WCAP-15050

HEJ Sleeved Tube  
Length Based Degradation  
Acceptance Criterion

**HEJ Sleeved Tube  
Length Based Degradation  
Acceptance Criterion**

## 8. NRC Staff Comments

Figure 4: Key to the HEJ Qualification Tests' Specimens

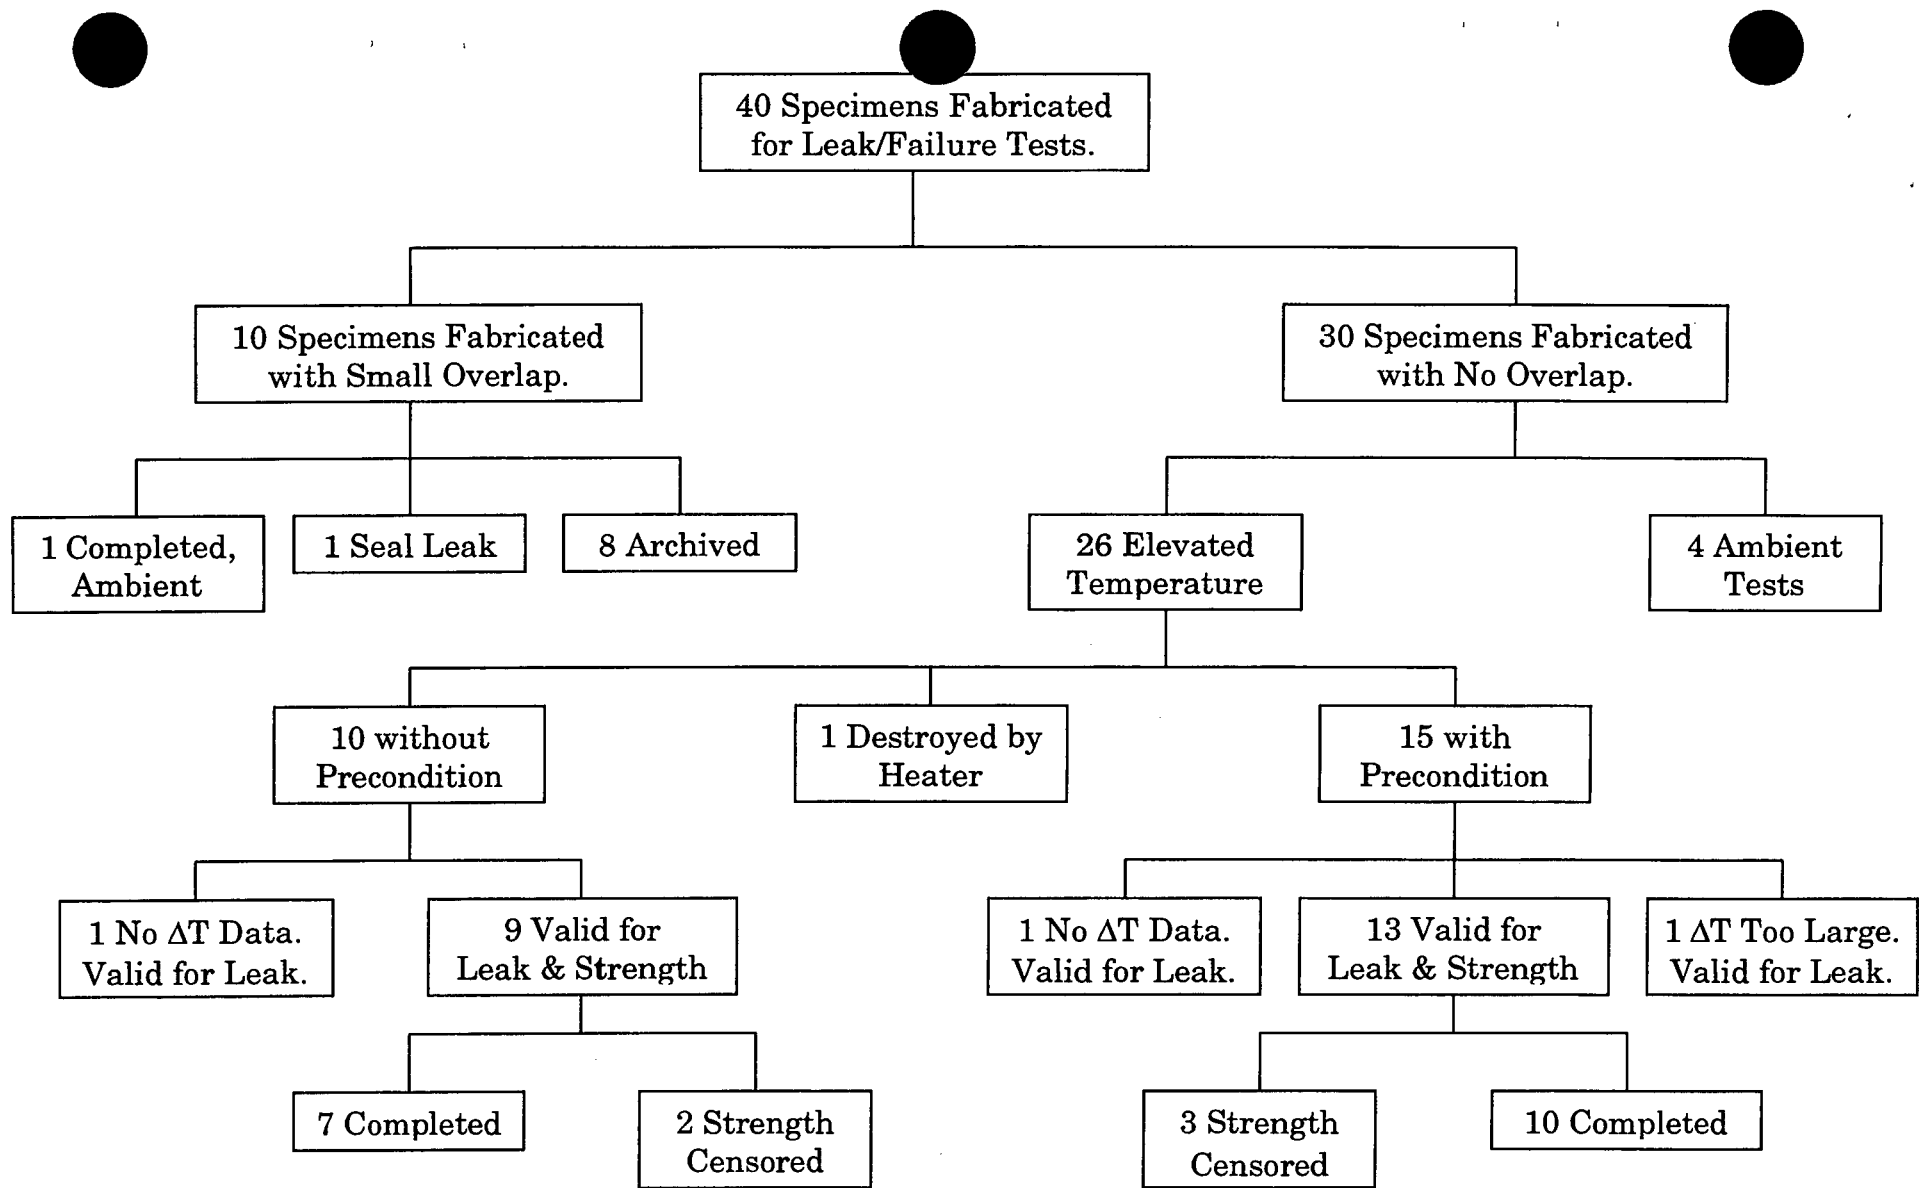
- 1) Delineate the data exclusion actions taken regarding each data point used in the evaluation.

The exclusion of the data is discussed in Section 3 and illustrated on Figure 4 of this report. In summary, only data from specimens for which a malfunction of the testing equipment was apparent were omitted from the analyses.
